COMMITTEE OF ADJUSTMENT

MINOR VARIANCE REPORT

APPLICATION: **CAV A/153/2022**

CAV A/153/2022 - 1235 Ingledene Dr (East District) (OP Designation:)

Excerpt of the Site Plan showing the side yard setback by the applicant:

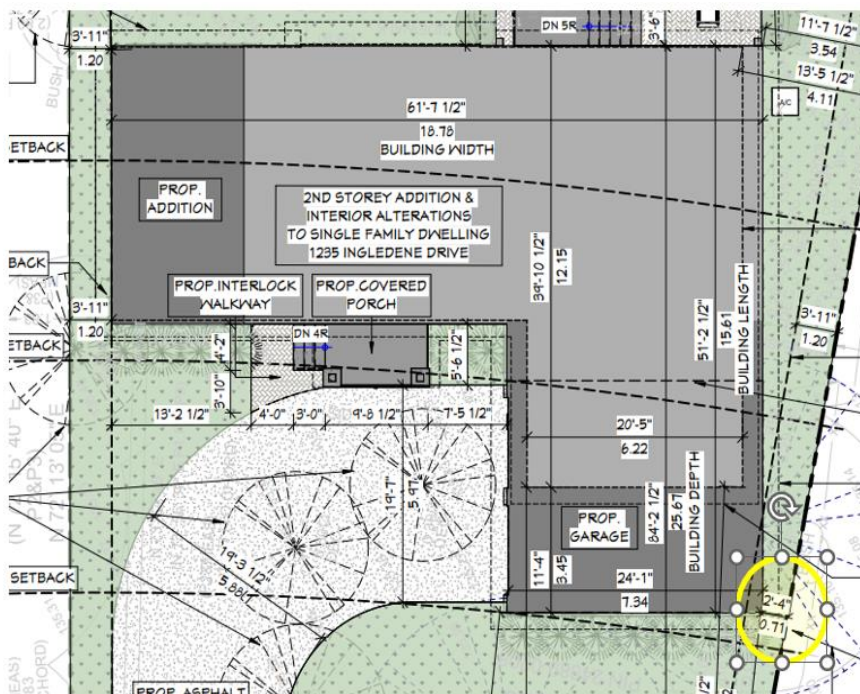
Variance #1 – Interior Easterly Side Yard (Unsupported)

The applicant requests relief from By-law 2014-014, as amended, to permit a reduced southerly interior side yard setback from a minimum of 1.2 metres to 0.71 metres. The side yard is measured from the southerly lot line to the main wall of the dwelling. The intent of regulating the side yard setback is to ensure sufficient spacing and buffering between buildings that are beside one another in order to provide adequate access and appropriate transition and scale, while also avoiding privacy and overlook concerns and to allow for adequate drainage. In this instance, an adequate separation is not provided between lots and the variance would have a negative impact on the adjacent property. Staff are of the opinion that this variance is not minor and would have negative impacts on adjacent properties.

Excerpt of the existing Site plan by the applicant

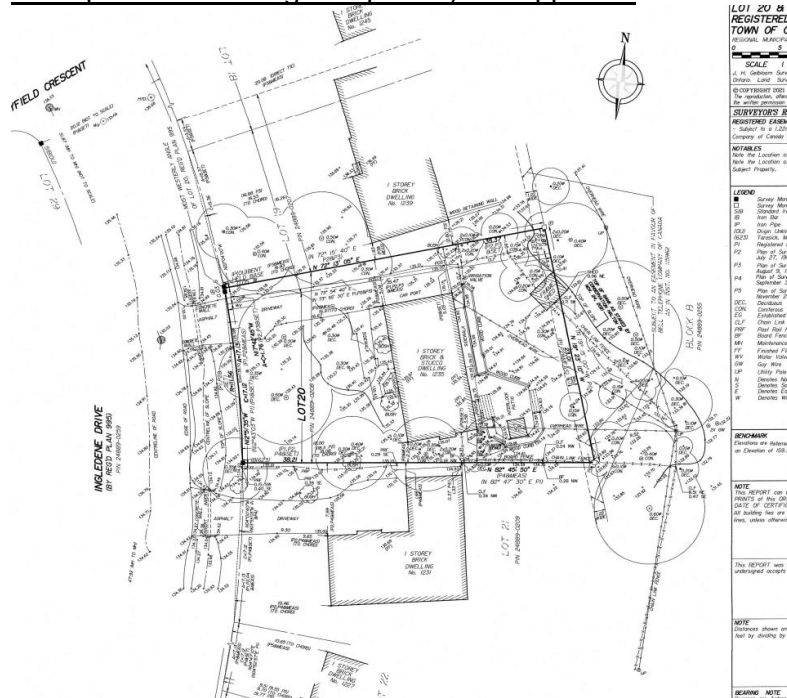
Variance #2 – Front Yard (Unsupported)

The applicant is requesting relief from Zoning By-law 2014-014, as amended, to permit a decrease in minimum front yard setback from 15.67metres to 9.18 metres. The front yard is measured from the front property line fronting on Inglede dr. to the front of proposed projecting garage of the dwelling. The intent of regulating the front yard setback is to ensure a relatively uniform setback along the street. The adjacent dwellings have very different setbacks to the

front lot line. The existing dwelling was more in line with the dwelling to the north than to the south with portion of the dwelling closer to the front lot line(Figure below). In this instance, the proposed dwelling does not facilitate an appropriate transition to the adjacent dwelling with projecting garage in the front. A decrease to the minimum front yard would exacerbate the condition along the streetscape and emphasize the inconsistent setback along the street. Staff are of the opinion that the cumulative impact of the front yard reduction and the other requested variances is not minor and is not desirable.
